NOTICE

PLEASE VERIFY BUILDING SITE LOCATION TO INSURE IT IS COMPATIBLE WITH SEPTIC TANK REQUIREMENTS NOTED ON SEPTIC PERMIT.

CONSTRUCTION NOTES

FRONT ELEVATION SCALE: 1/4" = 1'-0"

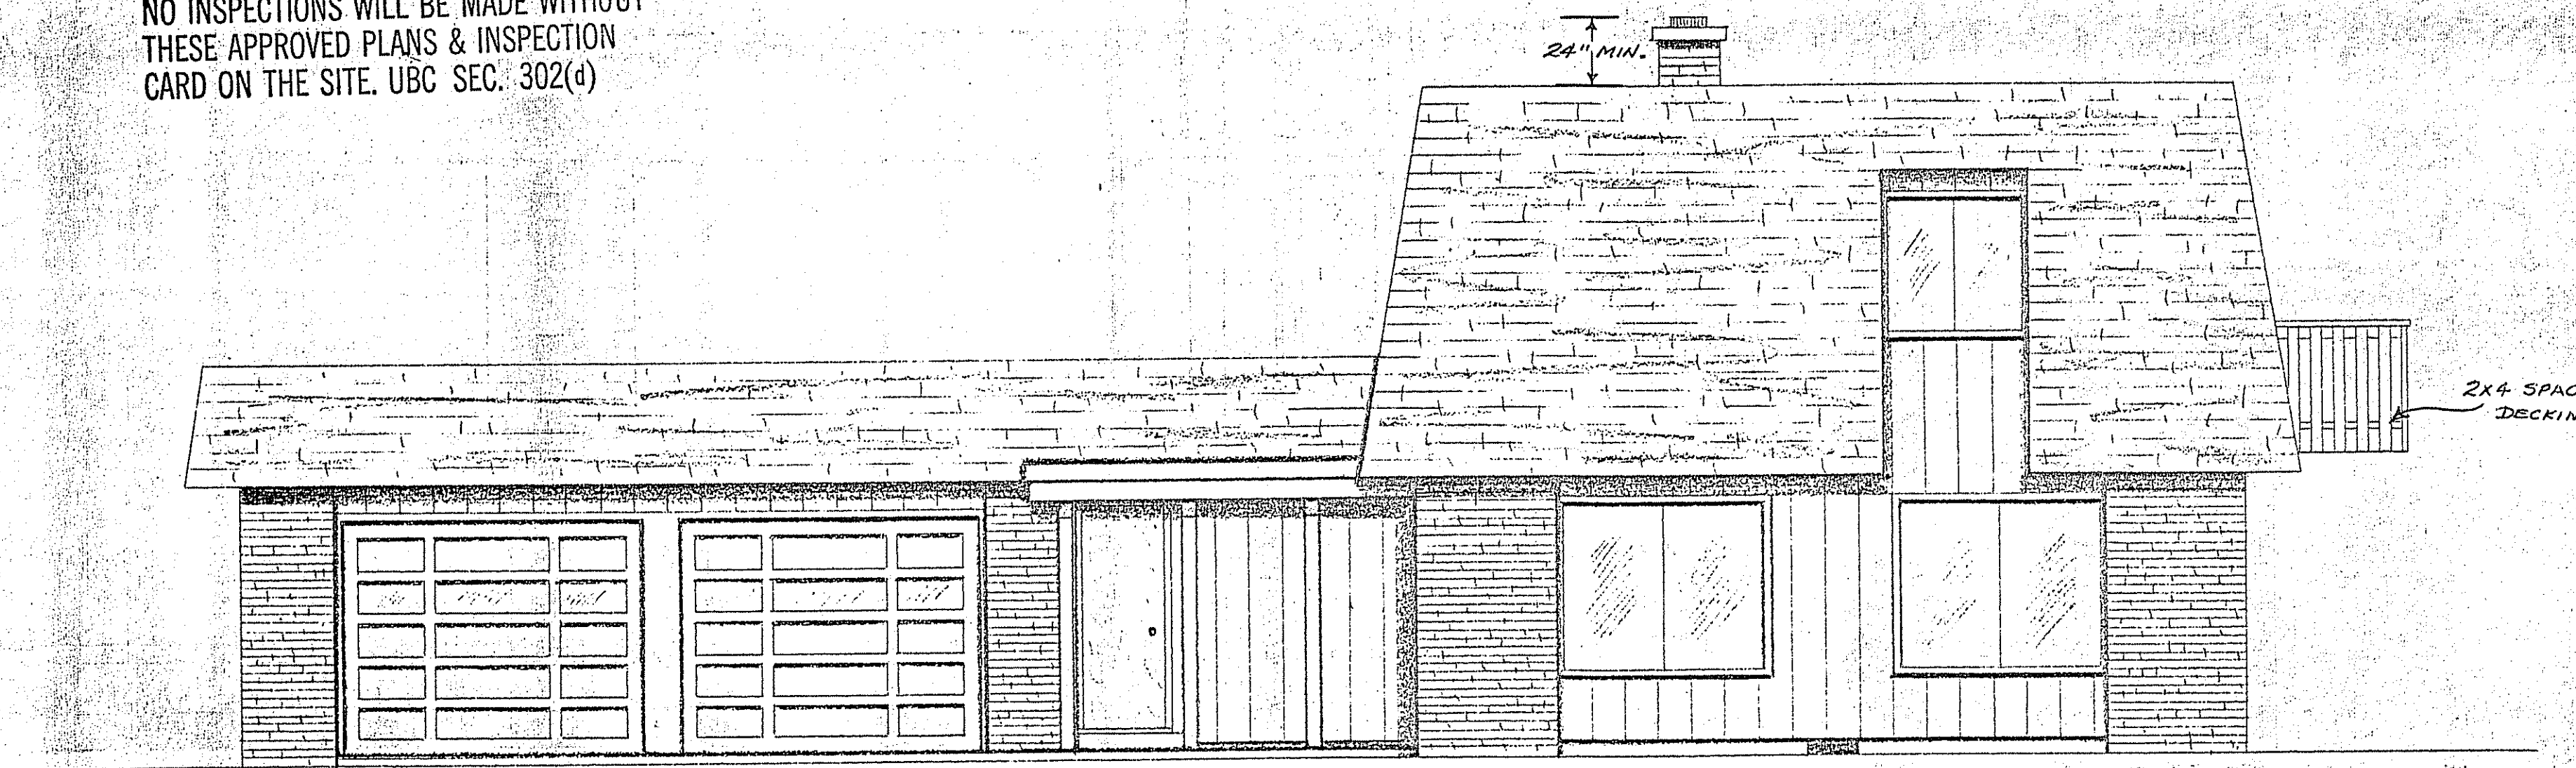
Fireplace and chimney construction shall conform to
Chapter 37 UBC.

LEFT ELEVATION SCALE: 1/4" = 1'-0"

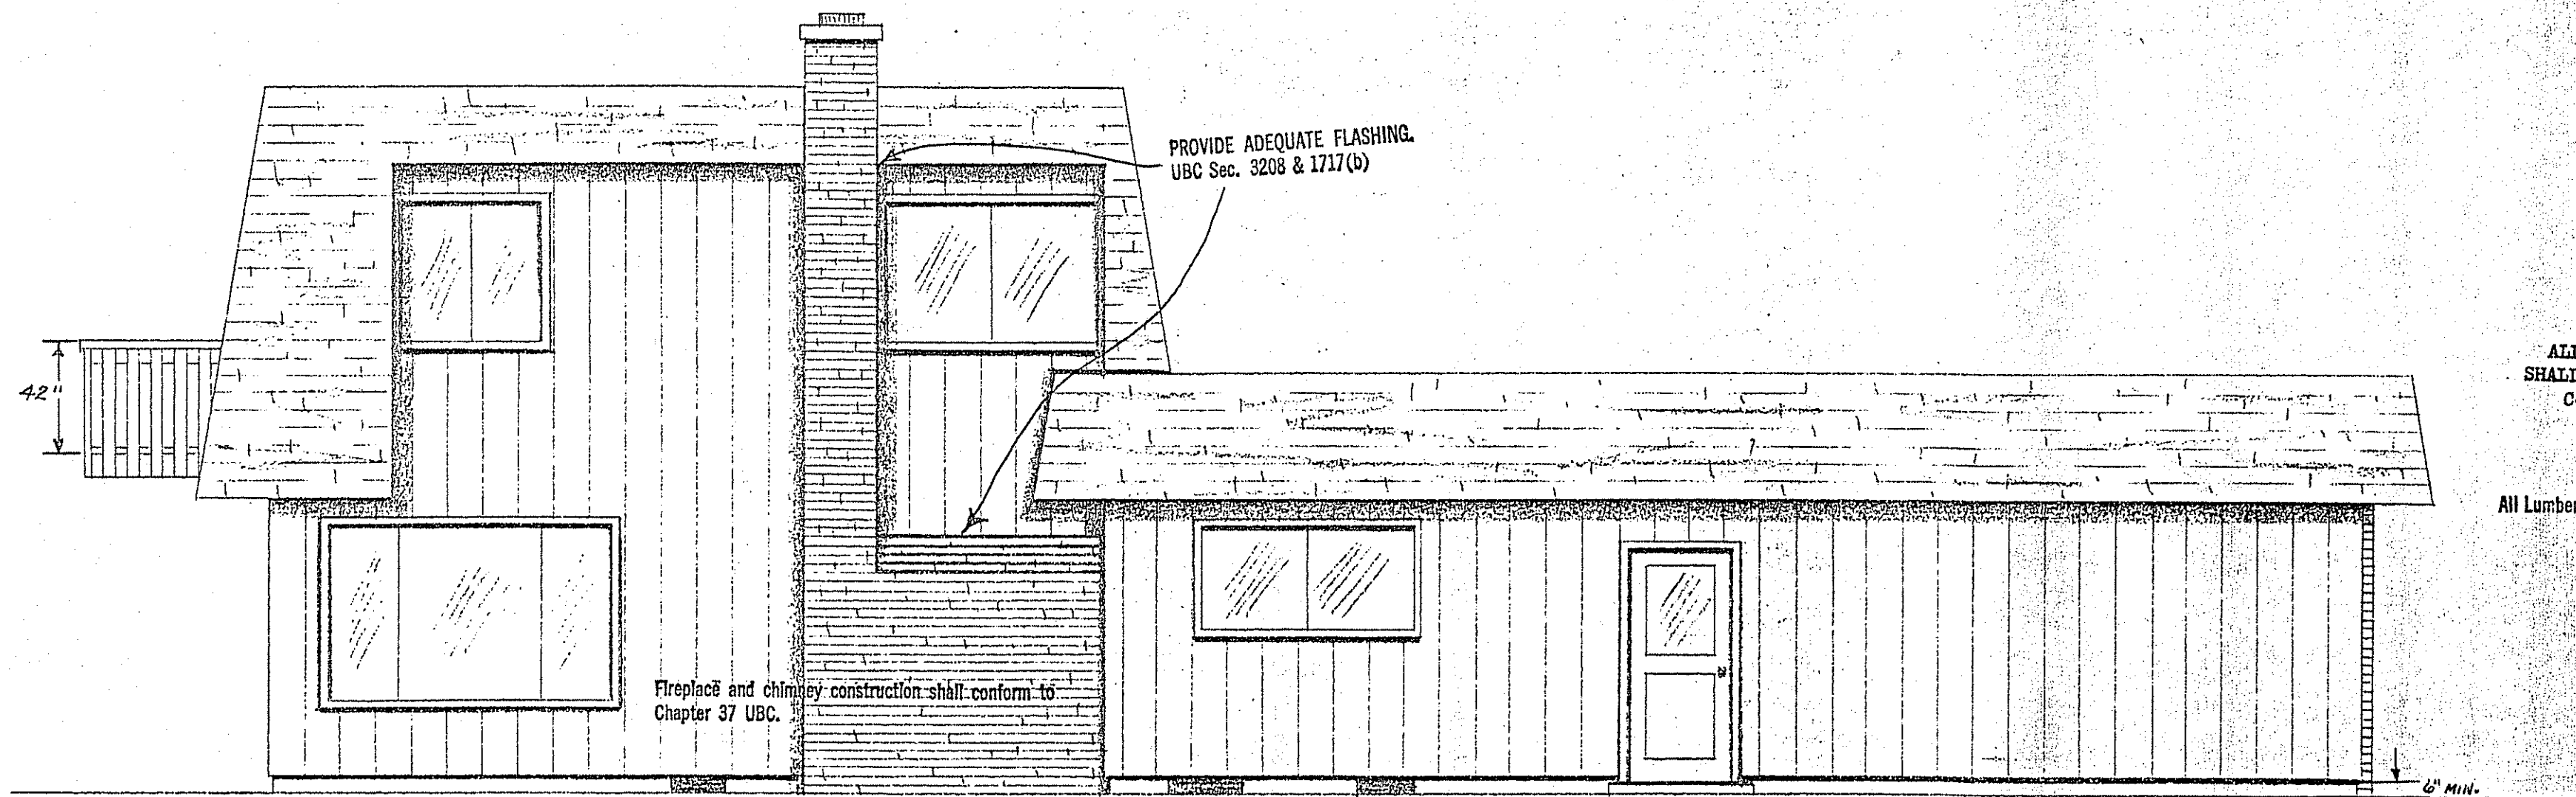
Where bottom of glass light is within 18" of floor and
all glass doors and wall panels of bathtub and shower
enclosures, must be of laminated, tempered or wired
(glass 5406 UBC).

This building shall not be occupied prior to
FINAL inspection without a TEMPORARY OCCUPANCY
permit from the Bldg. Official. Sec. 306(d) UBC.

Fireplace and chimney construction shall conform to Chapter 37 UBC.

PROVIDE ADEQUATE FLASHING.
UBC Sec. 3208 & 1717(b)

ALL WEATHER EXPOSED PLYWOOD
SHALL BE STAMPED EXTERIOR GRADE
C-C MIN GRADE ACCEPTABLE
